COMMENTS AND RESPONSE REPORT - EIA PHASE

Proposed “KRONOS-ARIES” 765kV Transmission Powerline & Substations Upgrades, Northern Cape Province

NEAS Ref: DEA/EIA/0001557/2012

DEA Ref: 14/12/16/3/3/2/440

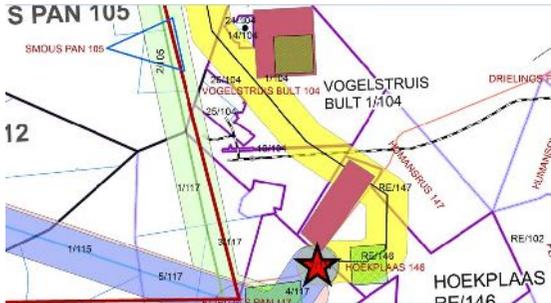
I&AP	Concerns & Queries	Date	Response from Mokgope / Eskom
	<p>which we will point out and discuss in further email discussions.</p> <p>Do you have a KMZ file with these planned routes that you can share with us?</p>		
<p><u>Landowner</u> Flip Zandberg</p>	<p>PPZandberg@chevron.com: Please sent me a detailed map indicating the farms the line will impact as well as the list of these farms.</p> <p>Wrt to my previous mail, the current line cross my property (Zandbergshoop , portion 1 and 3 of the farm Kokerberg) A portion of the line is crossing a wetland with serious corrosion because of the current line which Eskom tried to correct more than once without success.</p> <p>The situation is derationing and Eskom did not do what is supposed to be. My question wrt your EIA is: Who will fiscally inspect the terrain for me to point this out?</p> <p>And by when will the fiscally inspection be conducted? Surely an fiscal inspection need to form part of the EIA</p>	<p>06-11-15</p>	<p>EAP: Report and two maps have been sent to you via “wettransfer.com”</p> <p>Thank you for bringing this to our attention. Is it possible if you may indicate on the map where roughly the affected wetland is situated? I would like to alert the wetland specialist about it and then take it from there to recommend where the line may be deviated to avoid further impacts.</p> <p>A thorough walk-down with a qualified wetland specialist will be undertaken after the EIA Process. This would involve the various specialists to recommend tower positioning after negotiation process with the landowners. Eskom would be fiscally responsible for the walk-down process.</p> <p>I am not sure when the Walk-down would be conducted, but after Environmental Authorisation has been granted, the negotiation process will start. Negotiation process may take 2 years, depending on the issues that may delay the process. Each affected land owner will be notified and would be given a chance to indicate their conditions. At that stage, It would be an opportunity for you to arrange with the negotiator that when the wetland specialist is undertaking the walk-down near your area, you must be informed so that you are there with the Wetland specialist to indicate the area of concern.</p>
